**SIB 23 02 04**

Ball end joint loose on gear lever - Bulletin 23 002 04 (025)

Bulletin No: 23 002 04 (025)

Topic: Ball End Working Loose on Gearshift Lever.
F 650 CS

Picture 1

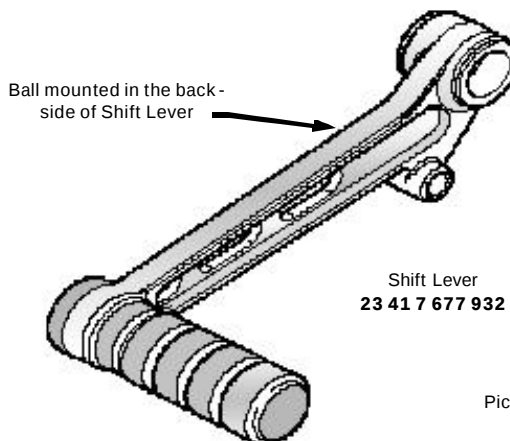
Subject: The ball end mounted on the inside of the gearshift lever can work loose. In the worse case this may cause the gearbox to shift with difficulty, or not at all.

Service: 1: Check the security of the ball end on the shift lever.
2: If the threaded ball end is found to have worked loose on the shift lever, remove the entire shift lever and install the modified shift lever with reworked ball end.

Part Number: 23 41 7 677 932

Description: Shift Lever
